| TSB130033                                    |                       |             |                     |

## Technical Service Bulletin

Engine Ignition Coil Broken at the Spark Plug End for ISL G CM2180, C Gas Plus and L Gas Plus CM556, and C8.3G CM420 Engines

Ignition coil extension broken at spark plug end.

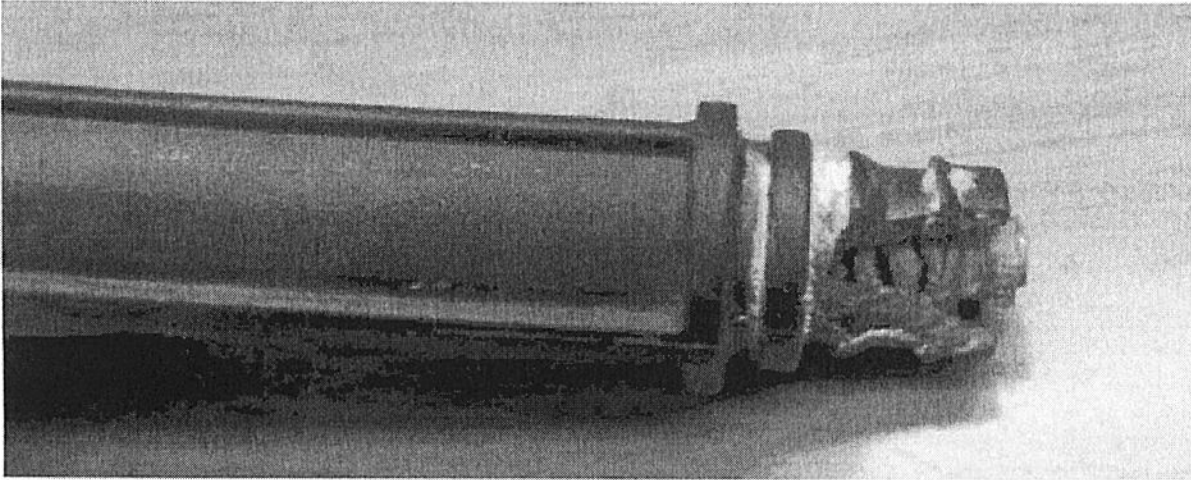
A misfire occurs due to an ignition coil extension broken at the spark plug end.

Root Cause: Inadequate clearance between the ignition coil extension and the spark plug ceramic allows removal/installation of the ignition coils while attached to the bracket.

This condition can be confirmed by checking for misfire fault codes. If they exist, check to confirm the ignition coil extension being broken at the spark plug end.

**NOTE:** Do not remove the entire bracket with the coils attached.

The manufacturing sub-assembly fixture/process was modified to position the ignition coils at the top of the slots in the coil bracket, Part Number 3933087.

Ignition coils on engines built before First ESN 73481931, date 12/07/2012, should be repositioned at the top of the slots in the coil bracket when being replaced/repared.

Ignition coils on engines built after ESN 73481931 have been positioned at the top of the slots during initial assembly and should continue to be maintained in that location when being repaired/replaced.
